Final Set, Jefferson Village Phase II  
(Bulletin 6)

JEFFERSON VILLAGE

TYPICAL PAVEMENT CROSS SECTIONS

HOR. SCALE: NO SCALE  
VER. SCALE: NO SCALE  
DATE: 3-27-00  
JOB NO.: DE99011  
FILE NO.: DE9911X1  
SHEET NO.: P-0.2

JEFFERSON VILLAGE  
INTERSECTION DETAILS  
ST. CLAIR AVE.

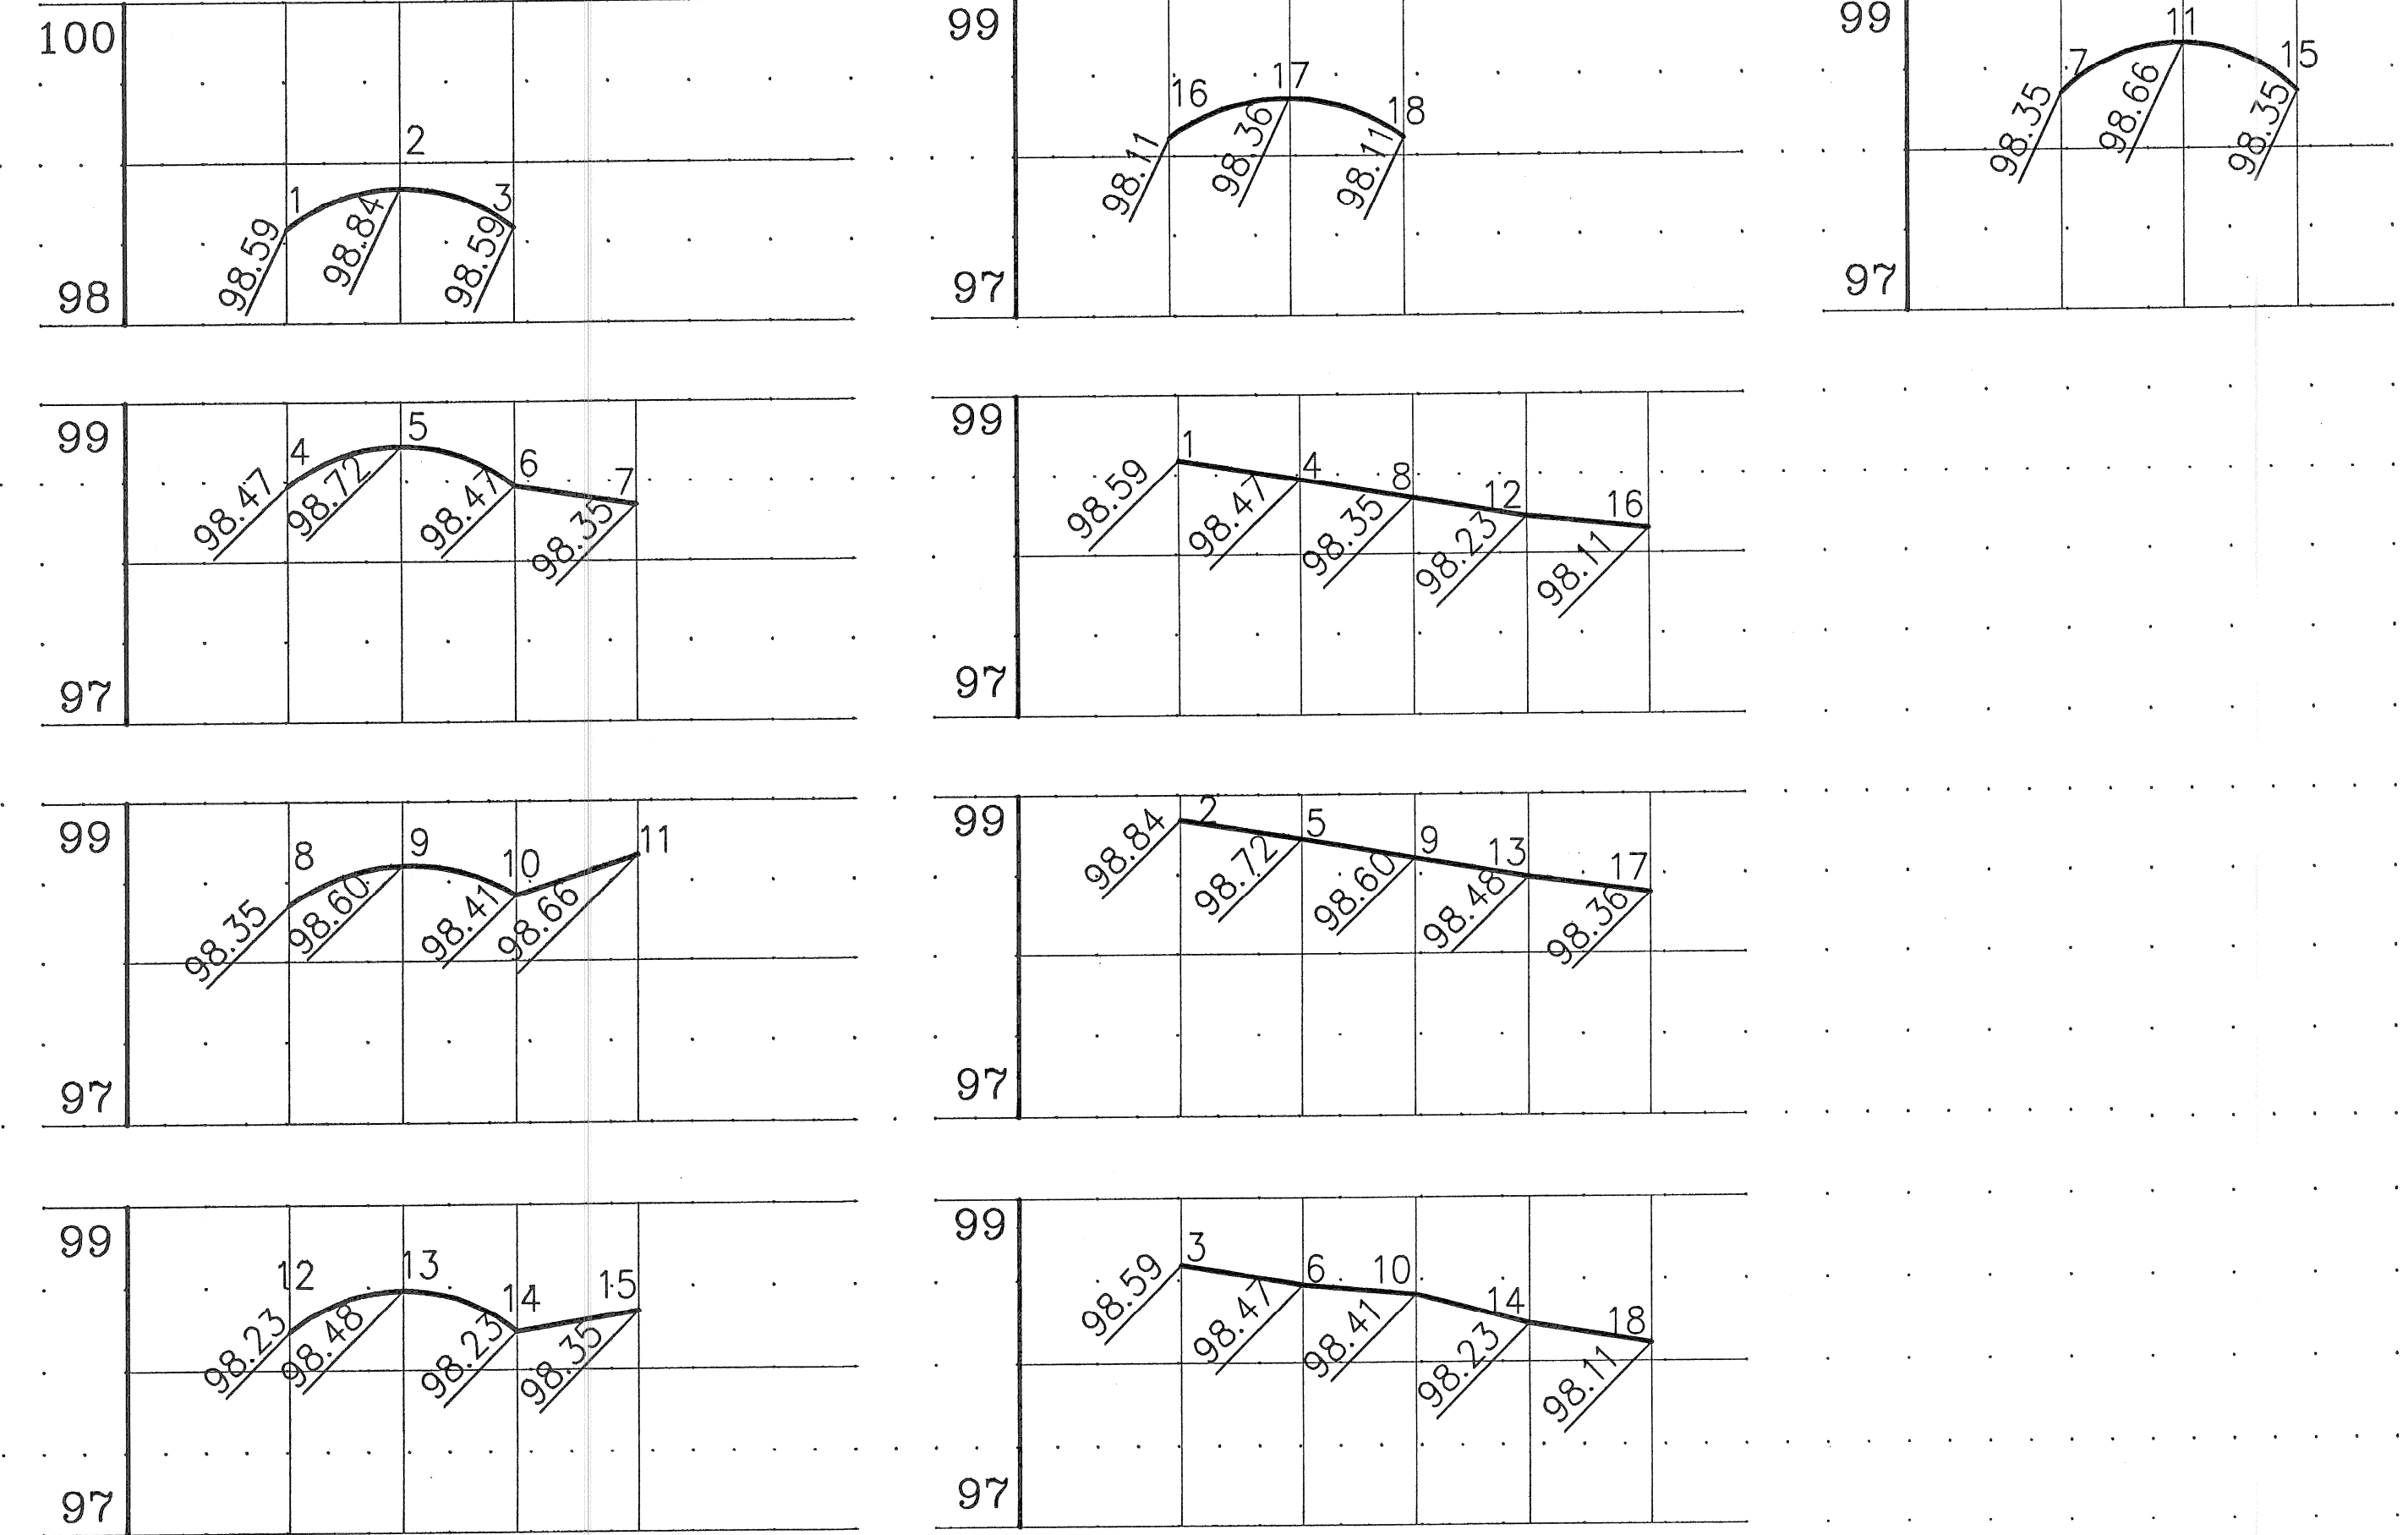
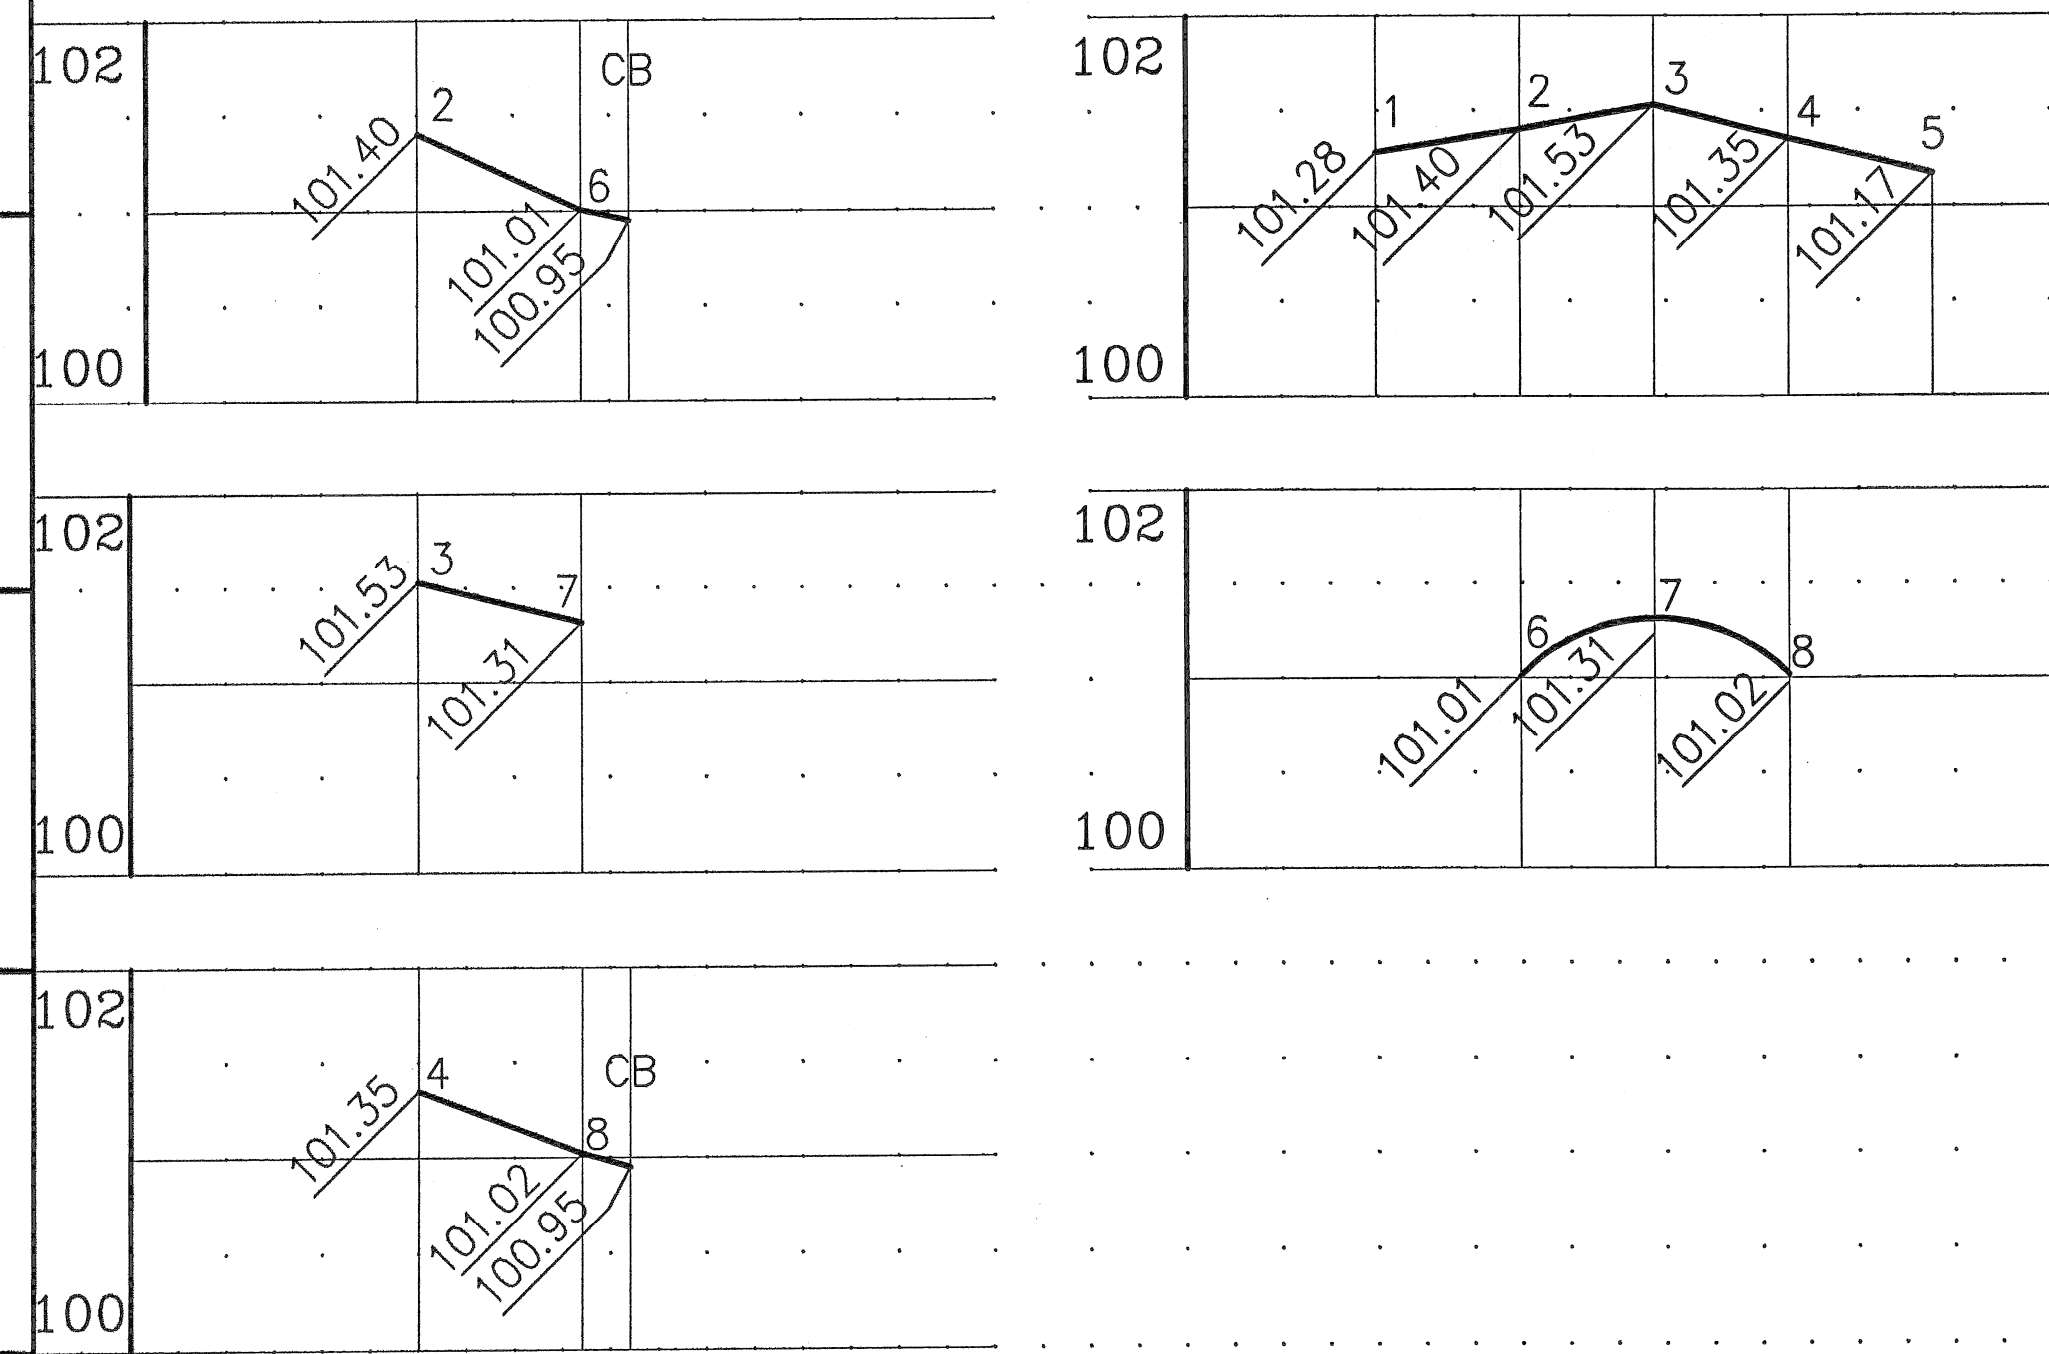
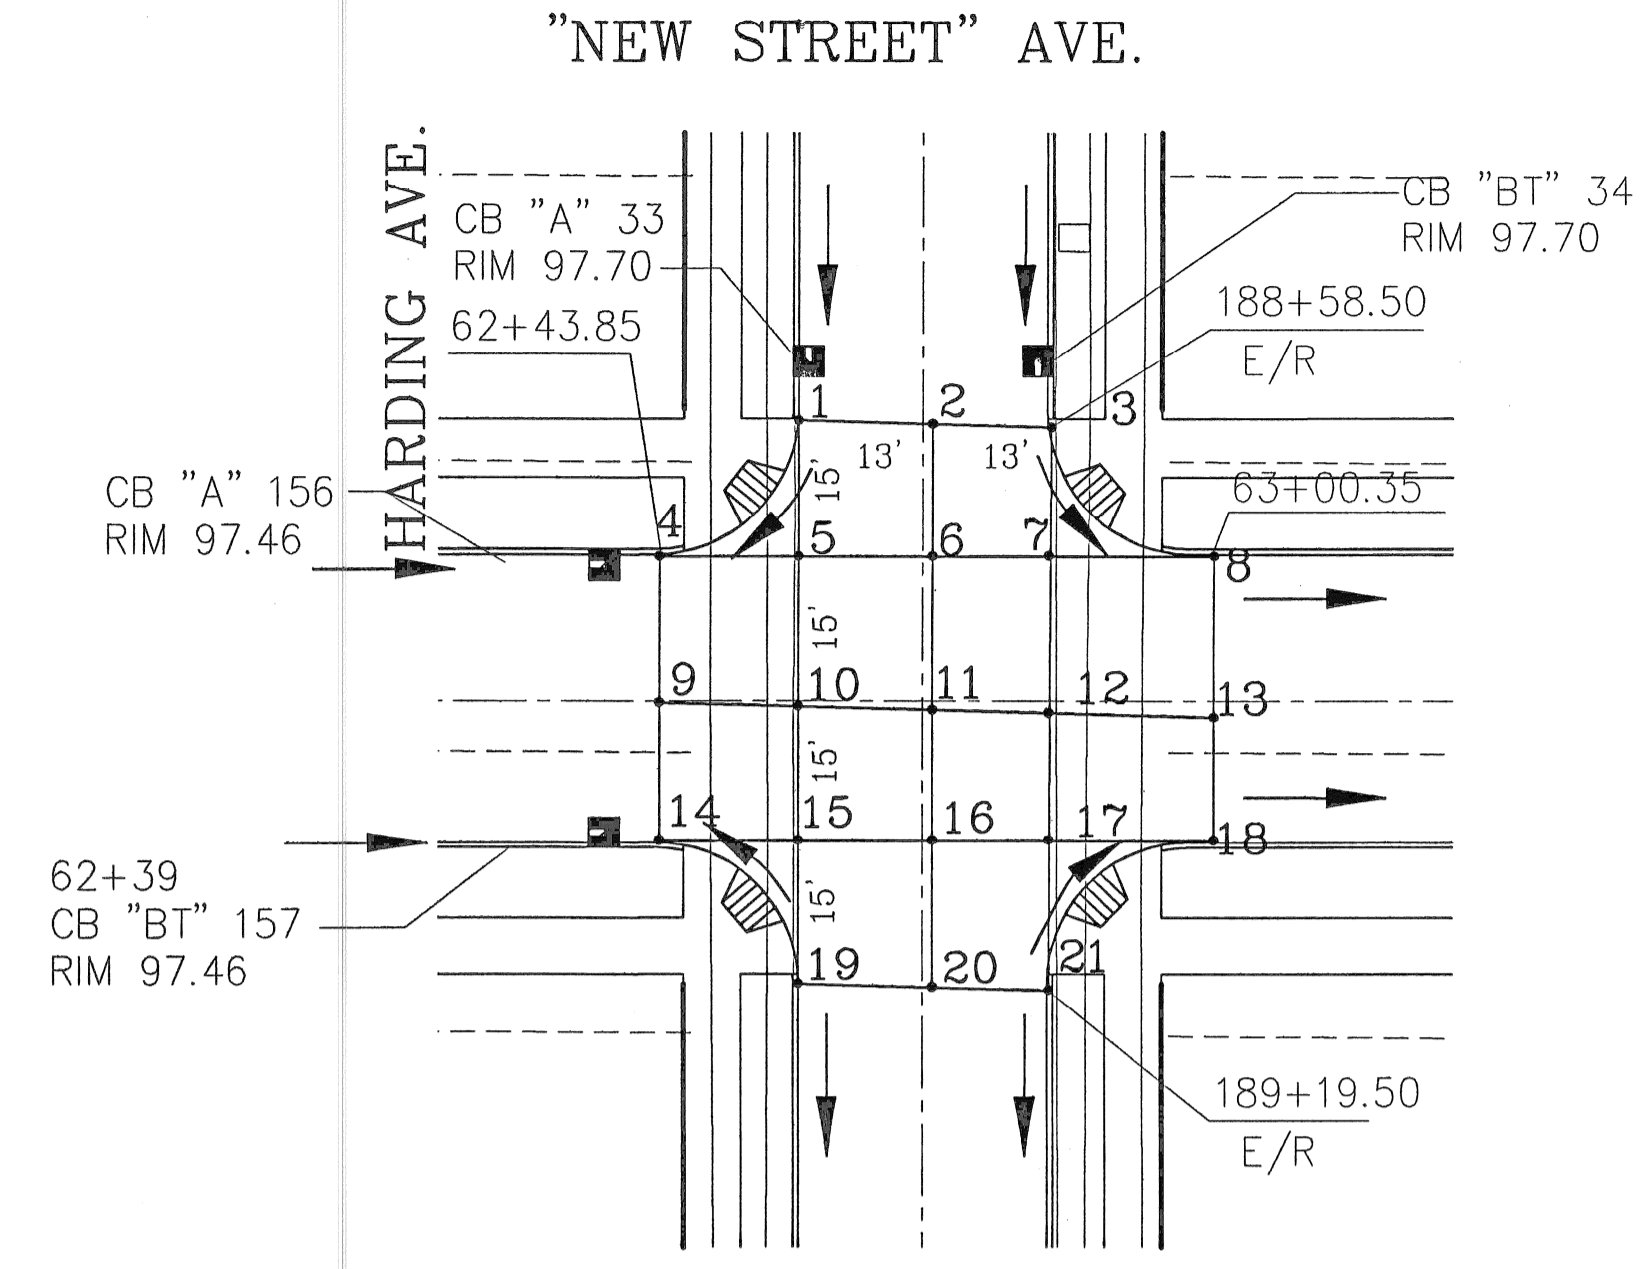
**NOTE:**  
WHERE PROPOSED ROLL CURB TIES INTO EXISTING CURB/7" HIGH CURB THE CONTRACTOR SHALL TAPER DIMENSIONS OF THE PROPOSED CURB OVER A LENGTH OF FIVE (5') FEET TO MATCH THE EXISTING/7" HIGH TOP OF CURB, FACE OF CURB AND BACK OF CURB. PAYMENT FOR THIS WORK SHALL BE CONSIDERED AS BEING INCLUDED IN THE COST FOR ALL OTHER CONCRETE PAVEMENT WORK.
